SUPPLEMENT INSTRUCTIONS

BAYSTAR[™]

CYLINDER MOUNTING PLATE FLIP

Figure A.

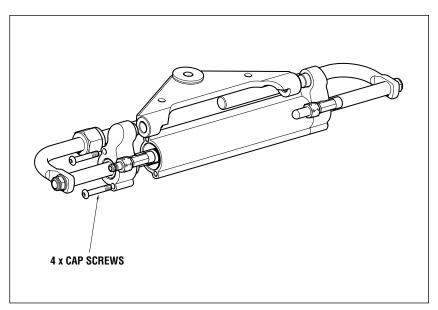
If your application requires the steering cylinder mounting plate to be flipped, you MUST add a small amount of a 'medium grade' thread locker (such as Loctite® 243) onto the threads of the 4 cap screws (see Figure A).

MUST use a medium strength thread locker on cap screws if removed and reassembled.
